SERVICE LETTER 173

10000 BULKHEAD 7, 10, AND 12 STIFFENER ADDITION

Aircraft Makes/Model(s):	Float Model(s):	Compliance: Mandatory	By: RCG
AT-802	10000A	Part Number: 1009163	Approved: JRS
AT-802A		Date: 9/18/2018	Revision: B

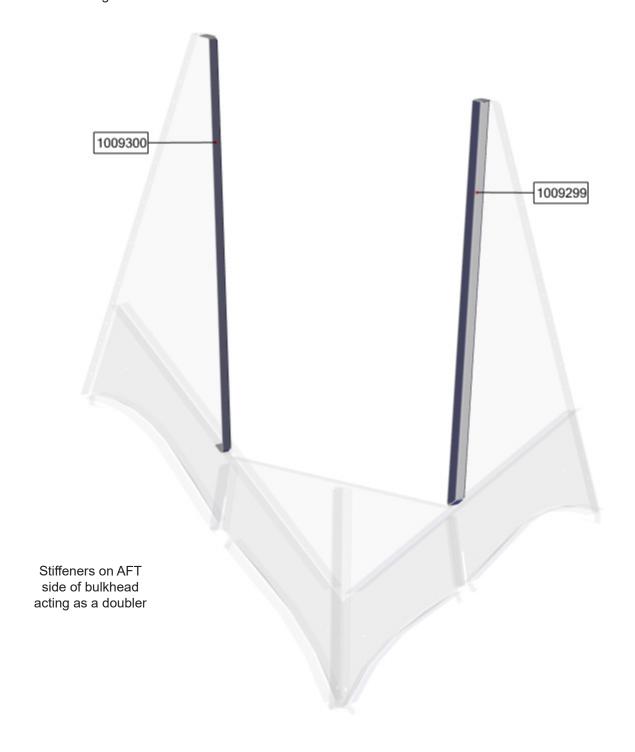
2. Inspect bulkhead 7 for cracking

Example of cracking in bulkhead 7. The damage is not limited to the area shown. Thoroughly check all of bulkhead 7.

3. If cracking is found in bulkhead 7, perform **method A** for repair. If no cracking is found in bulkhead 7, perform **method B** to prevent cracking

METHOD A - BULKHEAD 7 - CRACKS PRESENT

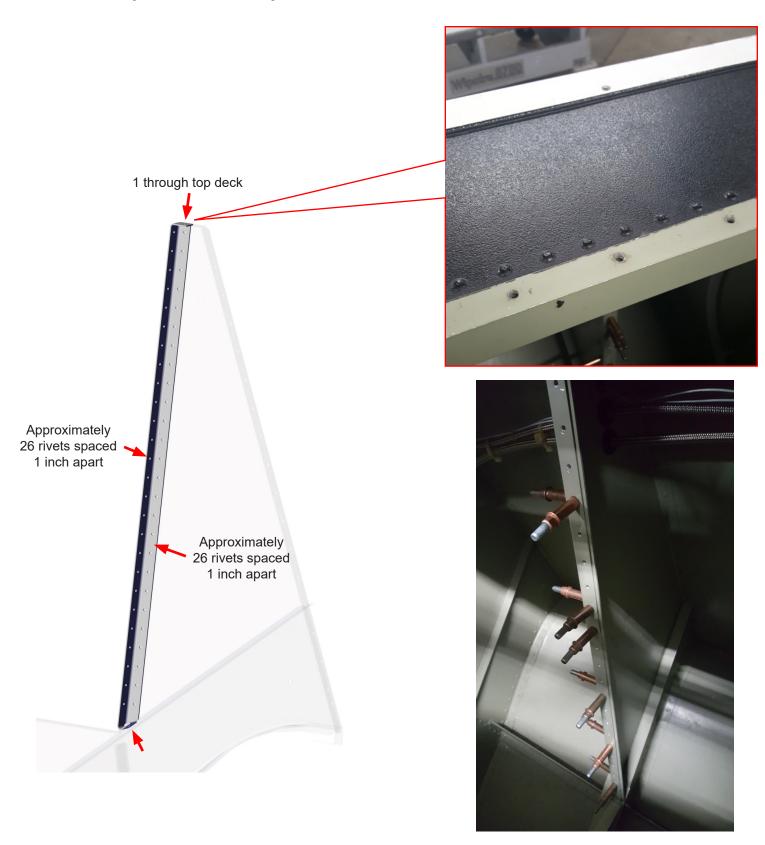
1. Place left and right stiffeners on AFT side of bulkhead as shown

2. Match drill stiffeners to bulkhead 7 and cleco into place as shown

NOTE: Consider edge distance when drilling holes

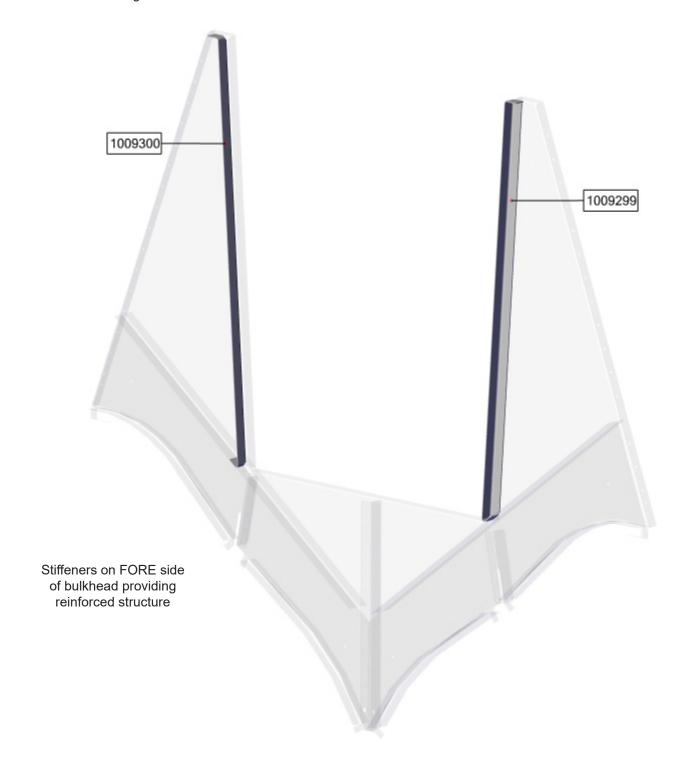
3. Rivet stiffeners in place as shown

METHOD B - BULKHEAD 7 - NO CRACKS PRESENT

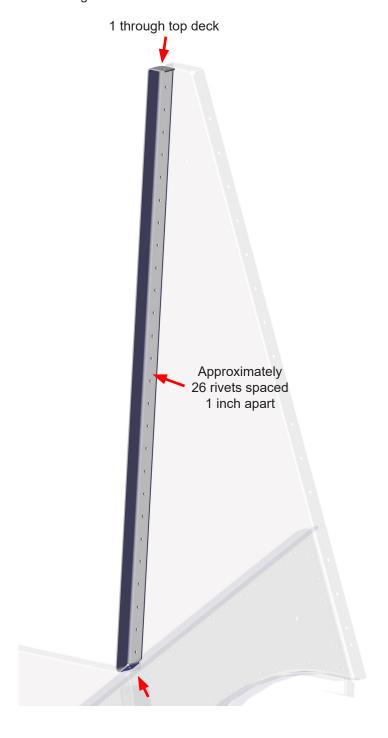
1. Place left and right stiffeners on FORE side of bulkhead as shown

2. Match drill stiffeners to bulkhead 7 and cleco into place

NOTE: Consider edge distance when drilling holes

3. Rivet stiffeners in place as shown

METHOD A - BULKHEADS 10 AND 12 - CRACKS PRESENT

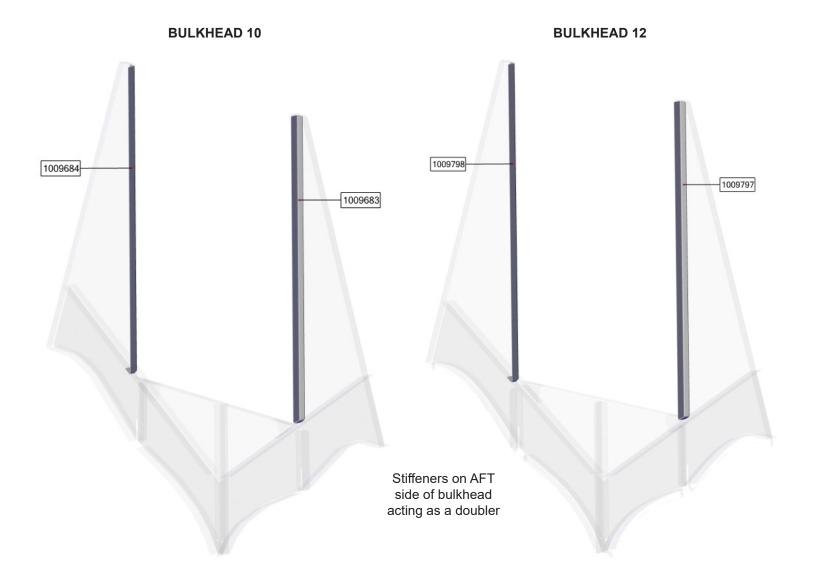
Perform method A if bulkhead 10 and/or 12 has cracks

1. Place left and right stiffeners on AFT side of bulkhead as shown

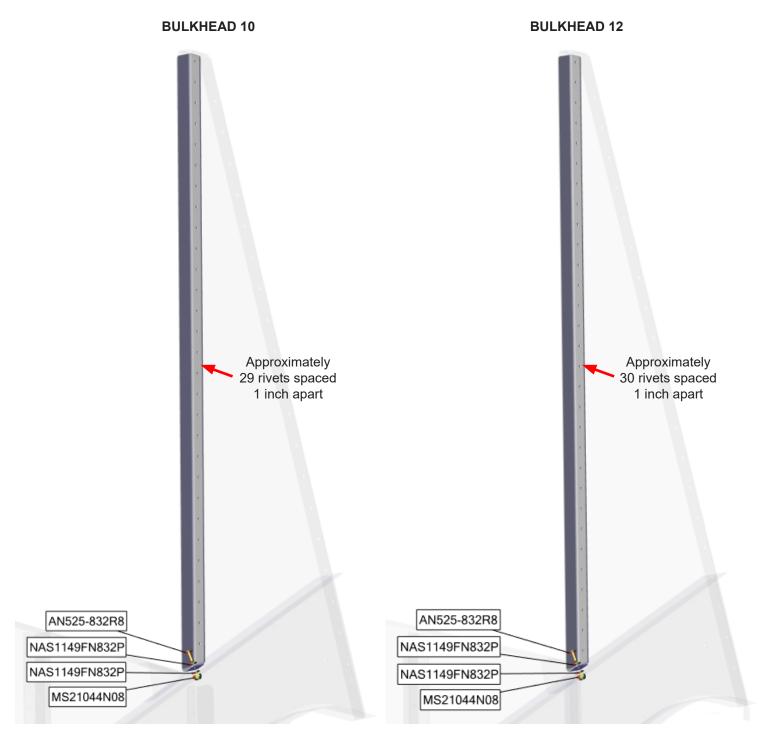
2. Match drill stiffeners to bulkhead 10 and/or 12 and cleco into place

NOTE: Consider edge distance when drilling holes

3. Rivet stiffeners in place and install hardware as shown

METHOD B - BULKHEADS 10 AND 12 - NO CRACKS PRESENT

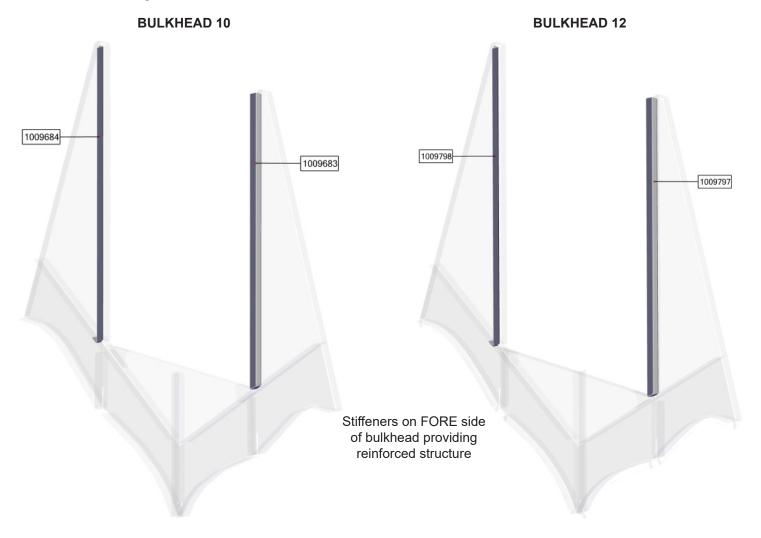
Perform method B if bulkhead 10 and/or 12 has no cracks

1. Place left and right stiffeners on FORE side of bulkhead as shown

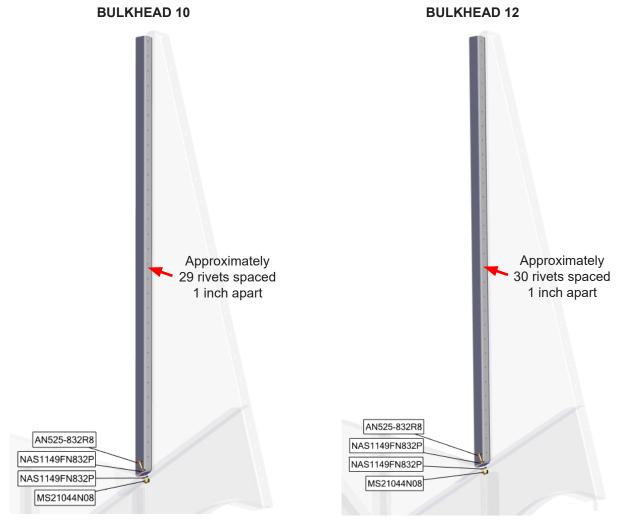
2. Match drill stiffeners to bulkhead 10 and/or 12 and cleco into place

NOTE: Consider edge distance when drilling holes

3. Rivet stiffeners in place and install hardware as shown
